**Committee of Experts on the Transport of Dangerous Goods  
and on the Globally Harmonized System of Classification  
and Labelling of Chemicals**

**Explosives and related matters: improvement of test series 8**

**Recommendations on Test Series 8: Applicability of Test  
Series 8 (d)**

**Transmitted by the Institute of Makers of Explosives (IME)**

**Figure 1: Comparison of Koenen, VPT, and MBP Tests for Ammonium Nitrate and Water-based Emulsion (ANWE) products with varying Water Content. (MBP data after (1))**

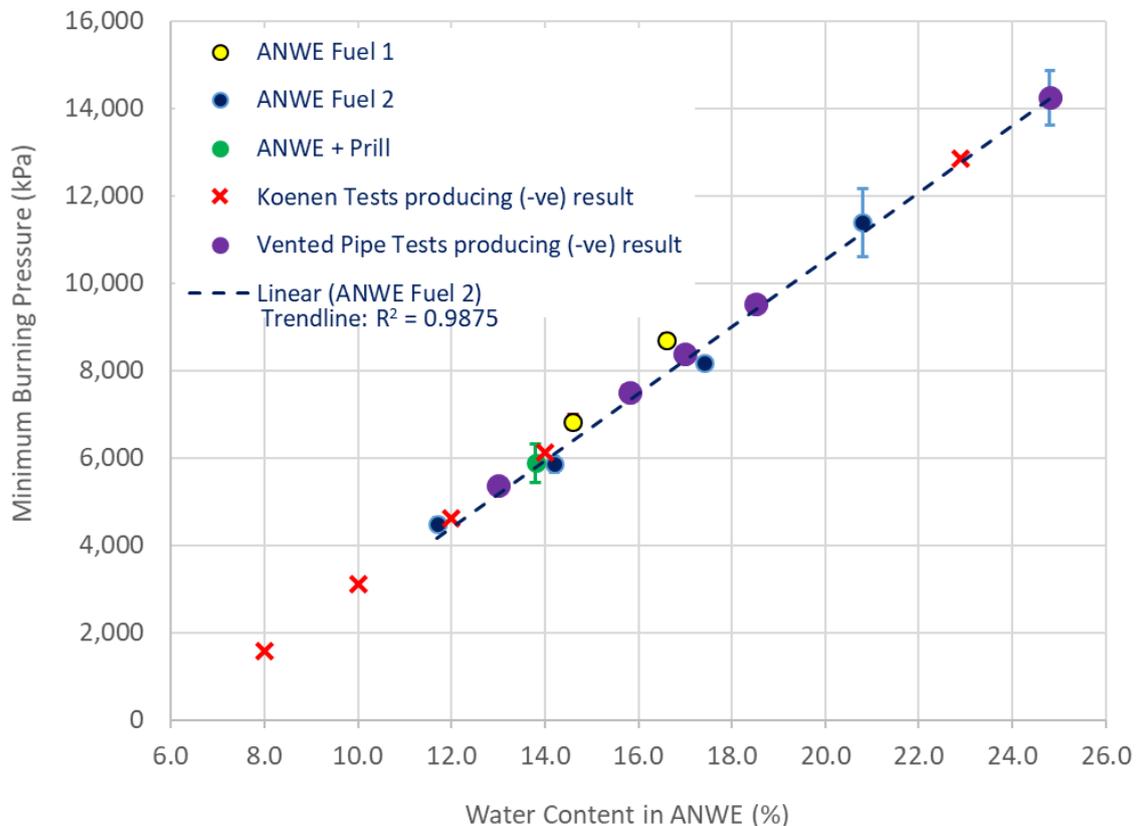
6. One critical reason for introducing the MBP 8 (e) test alternative to 8 (c) was the inability of the Koenen Test to differentiate between ANEs of widely varying water contents, a key determinant of ANE reactivity. This issue is demonstrated in Figure 1 (reproduced from informal document INF.22 (53<sup>rd</sup> session)) that clearly shows the superior differentiation capability of the 8 (e) test.

7. A similar issue with lack of discrimination of water content has been identified in the Vented Pipe Test (8 (d)). Figure 1 shows results of 8 (d) test outcomes for ANEs as a function of their MBP for different water contents, and using a consistent fuel phase to that of ammonium nitrate and water-based emulsions (ANWE) Fuel 2.

9. The results in Figure 1 and Table 1 show that the 8(d) test cannot differentiate between a Div 5.1 and Div 1.5 substance, which highlights its limited usefulness in predicting the behavior of an ANEs during transport in a portable tank.

10. ANEs that satisfy the acceptance criteria of the 8(e) test should not be subjected to the 8(d) test and can be considered suitable for transport in portable tanks as oxidizing substances based on the 8(e) results.
